| Project | IEEE 802.16 Broadband Wireless Access Working Group < http://ieee802.org/16 > |
| Title | Proposed text and ASN.1 code to support multicast polling |
| Date Submitted | 2007-05-02 |
| Abstract | This contribution proposes the text and ASN.1 code in wmanIf2Mib to support CID update TLV. |

Figure 4— wmanIf2BsCps structure

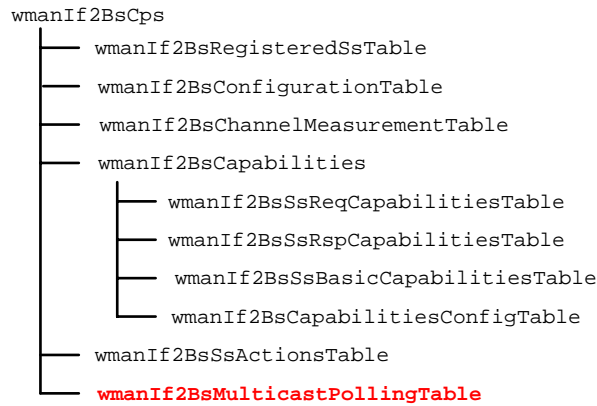
[Change Figure 4 as the following:]
